UNITED STATES PATENT AND TRADEMARK OFFICE

APPLICATION NO.	FILING DATE	FIRST NAMED INVENTOR	ATTORNEY DOCKET NO.	CONFIRMATION NO.
10/562,681	08/21/2006	Robert Yaw Gyamfi Andoh	P08829US00/MP	4066
881 7590 01/12/2009 STITES & HARBISON PLLC 1199 NORTH FAIRFAX STREET SUITE 900 ALEXANDRIA, VA 22314			EXAMINER MELLON, DAVID C	
			ART UNIT 1797	PAPER NUMBER
			MAIL DATE 01/12/2009	DELIVERY MODE PAPER

Office Action Summary

DETAILED ACTION

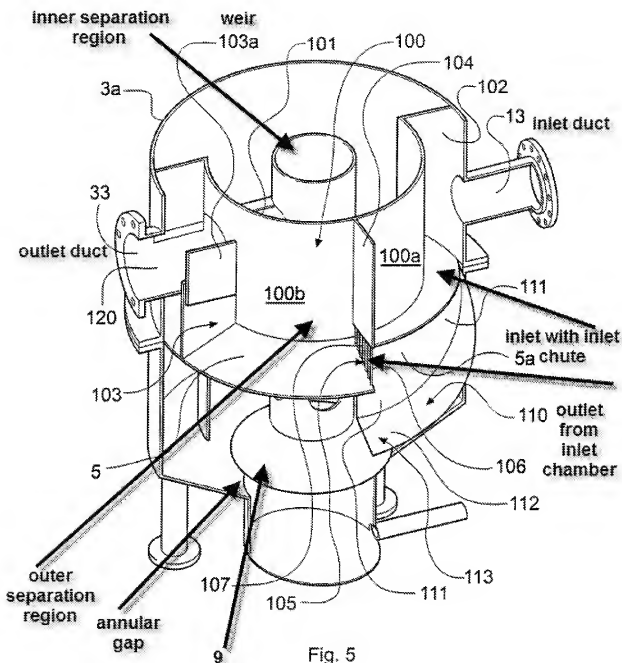
Regarding claims 1-2, Andoh et al. discloses a hydrodynamic separator for separating material from a liquid (abstract) in figures 1, 4-6 comprising:

- A vessel (2) having a cylindrical outer wall (3)

- An inner partition (chamber – 31)
- An inlet (13) opening into the outer separation region (see annotated figure 5)
- An outlet (33) opening into the inner separation region (see annotated figure 5)
- A frustoconical base (9) which converges to a downward outlet opening (8a).

Regarding claim 12, Andoh et al. further discloses that the wall (9) terminates short of the frustoconical base of the vessel, creating a gap between the base and the wall (see annotated figure 5).

Regarding claims 16 and 17, Andoh et al. further discloses an outlet duct that extends from the liquid outlet through the outer wall of the vessel and is inline with the inlet duct which extends through the outer wall (see annotated figure 5, inlet and outlet 13 and 33 extending through vessel wall and inline with one another).

Regarding claim 18, Andoh et al. further discloses an inlet disposed below the inlet duct (see annotated figure 5) with an inlet port to discharge inlet flow into the vessel in a tangential direction to the cylindrical outer wall (inlet chute is wrapped around the cylindrical wall).

Regarding claims 23 and 24, Andoh et al. further discloses that the inner partition (31) is cylindrical (shown in annotated figure 5) and that the inner partition is coaxial with the outer wall (see figure 4).
